# GeoAPI changes

<b>TITLE:</b>	<b>GeoAPI alignment with standards</b>
<b>AUTHORS:</b>	<b>Martin Desruisseaux, Adrian Custer (Geomatys) Jody Garnett, Cory Horner, Graham Davis (Refractions Research)</b>
<b>DATE:</b>	<b>June, 2007</b>
<b>CATEGORY:</b>	<b>Change Proposal</b>

The diagram below summarizes the name interfaces if 4.1, 4.2 and 4.3 are accepted.

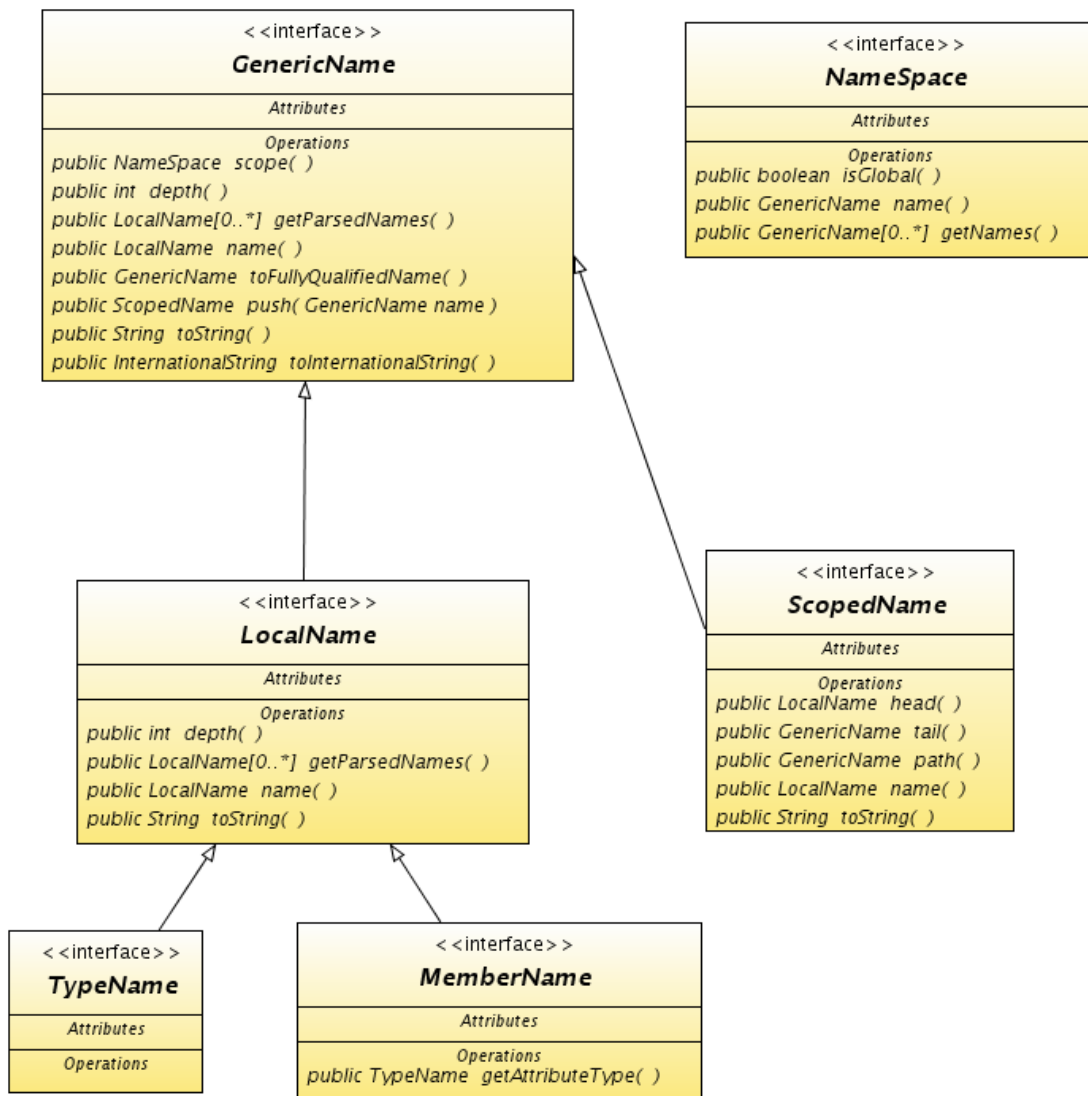
We propose to add a `NameSpace` interface in GeoAPI 2.1/3.0 derived from ISO 19103:2005, associate `GenericName` to this `NameSpace` through a new `scope()` method, and deprecate the current (erroneous) `getScope()` method.

In addition, we propose to add the `head()` and `tail()` methods (derived from ISO 19103) into the `ScopedName` interface.

We propose to add the `NameSpace` interface in the `org.opengis.util` package with the following methods derived from ISO 19103:

We propose to deprecate the current `GenericName.getScope()` method (which was used to return another `GenericName`) and add the following method in `GenericName` instead:

We propose to add the following methods in `ScopedName`:

- `LocalName head()`;  
Synonymous for the current GeoAPI's `asLocalName()` method, but with naming conformant to ISO 19103.
- `GenericName tail()`;  
Replace the `getScope()` method deprecated above, with identical functionality but with naming conformant to ISO 19103.

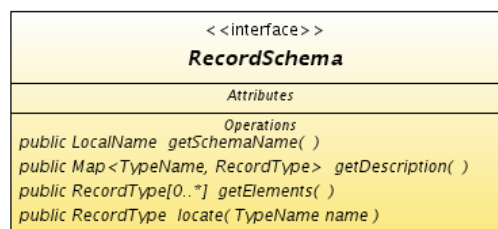
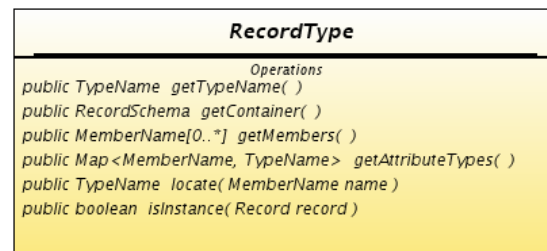
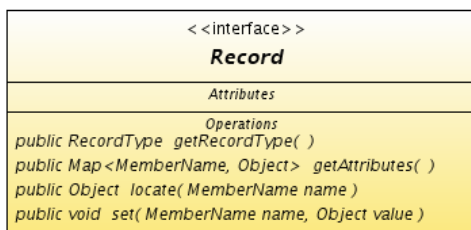
Add the interfaces illustrated in the diagram below. Note that the proposed interfaces contains 3 methods not defined in ISO 19103, listed before the diagram. Those methods expose in a more explicit way some functionalities that would be provided anyway by pure ISO 19103 interfaces, in an attempt to reduce the confusion.

- **`void set(MemberName name, Object value)`**  
Set the value for the attribute of the specified name. This is functionally equivalent to `getAttributes().put(name,value)`. Remind that name keys are constrained to `RecordType.getMembers()`.

- **`Set<MemberName> getMembers()`**  
Returns the set of attribute names defined in this `RecordType`'s dictionary. If there are no attributes, this method returns the empty set. This method is functionally equivalent to `getAttributeTypes().keySet()`. The `Namespace` associated with a `RecordType` contains only members of this `RecordType`. There is no potential for conflict with sub-packages.

- **`boolean isInstance(Record record)`**  
Determines if the specified record is compatible with this record type. This method returns true if the specified `record` argument is non-null and the following condition holds: `getMembers().equals(record.getAttributes().keySet())`

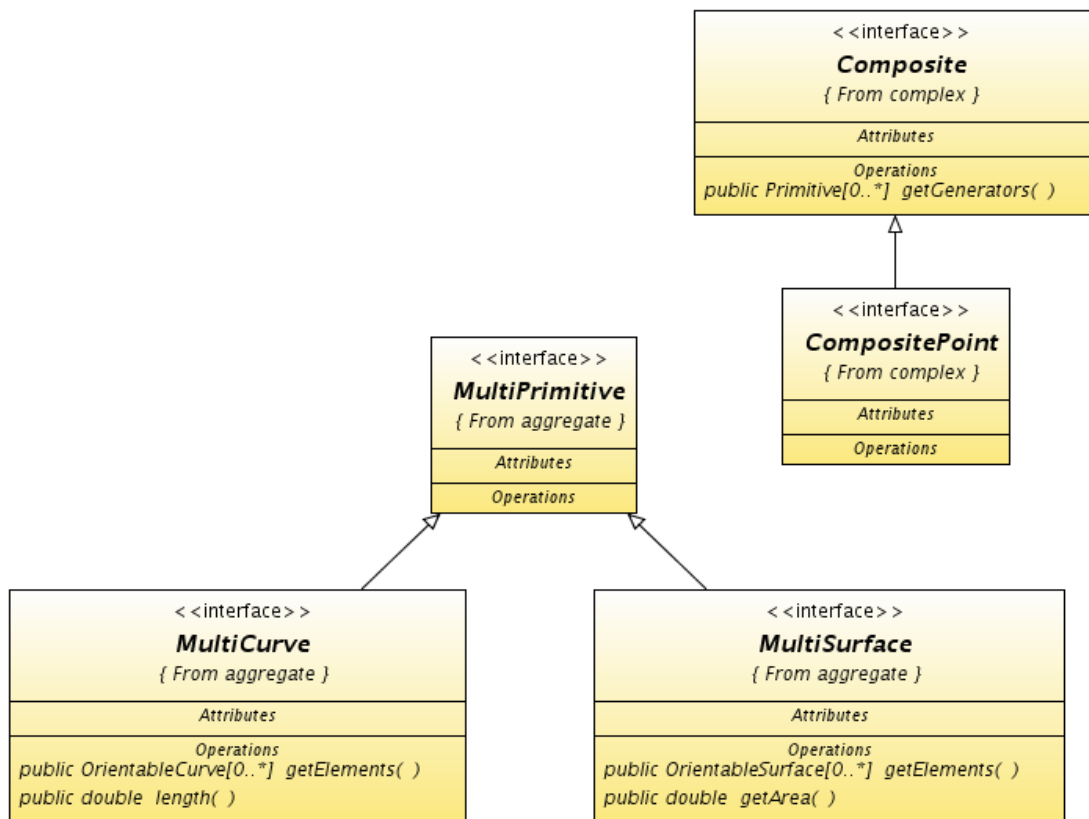
Add the `MultiCurve`, `MultiSurface` and `CompositePoint` interfaces illustrated in the diagram below. Note: `MultiPrimitive` and `Composite` interfaces already exist and are unchanged.
